UPDATE CHANGE NOTIFICATION # 20656Generic Copy

Issue Date: 12-Nov-2014**TITLE:** Update notice of FPCN20656 to correct the assembly site and case outline information.**PROPOSED FIRST SHIP DATE:** 25-Dec-2014**AFFECTED CHANGE CATEGORY(S):** ON Semiconductor Assembly & Test**ADDITIONAL RELIABILITY DATA:**Contact your local ON Semiconductor Sales Office or Reliability Engineer Chean Ching Sim
<cheanching.sim@onsemi.com>**SAMPLES:** Contact your local ON Semiconductor Sales Office**FOR ANY QUESTIONS CONCERNING THIS NOTIFICATION:**

**UPDATE CHANGE NOTIFICATION #20656**

Figure 1:

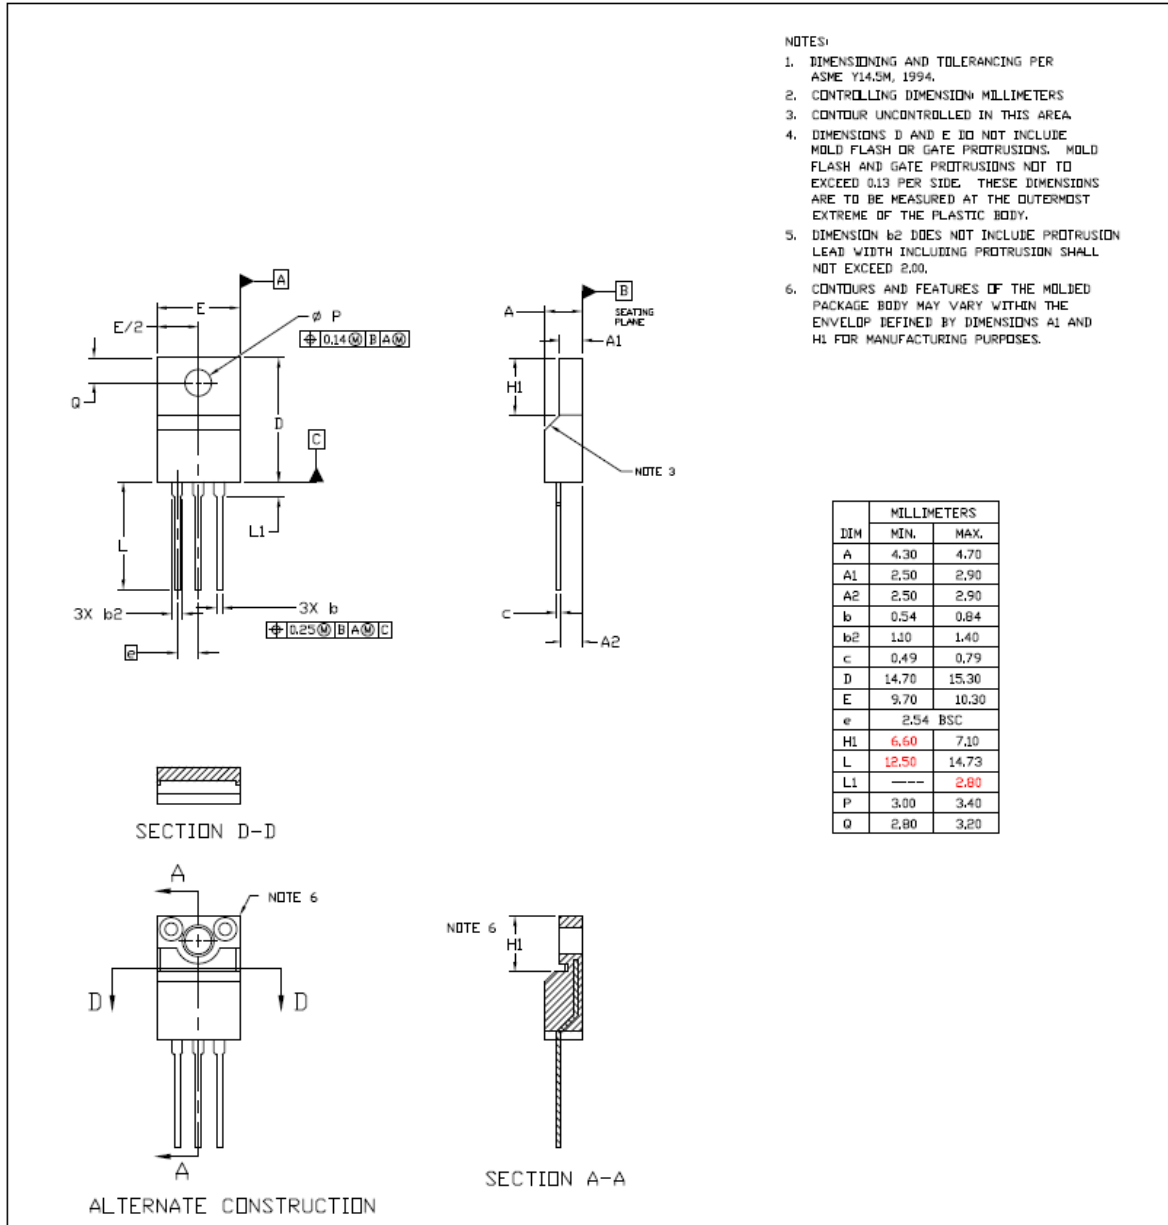
With this change the following devices will require a modification to the case outline as shown below in Figure 1.

MURF1620CTG
MURHF860CTG
MURF1660CTG
NDF02N60ZH
NDF03N60ZH
NDF08N60ZH
NDF04N60ZH
NDF05N50ZH
NDF06N60ZH
NDF08N50ZH
NDF10N60ZH
NDF11N50ZH

Figure 2:

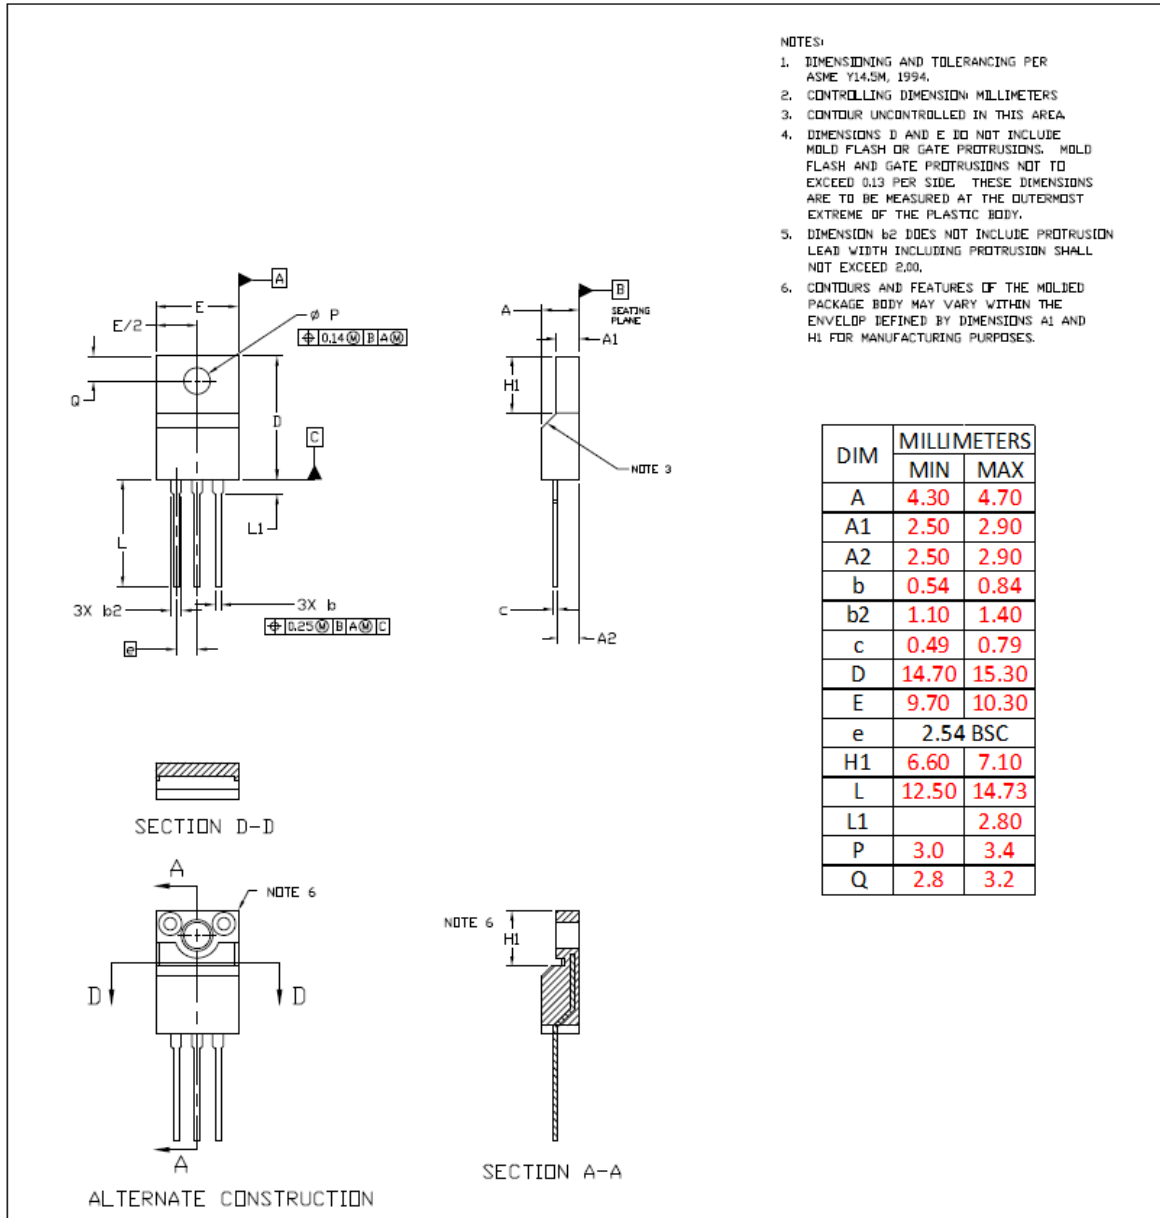
With this change the following devices will require a modification to the case outline as shown below in Figure 2.

NDF05N50ZG
NDF08N50ZG
NDF11N50ZG
NDF02N60ZG
NDF08N60ZG
NDF10N60ZG
NDF06N60ZG
NDF03N60ZG
NDF04N60ZG
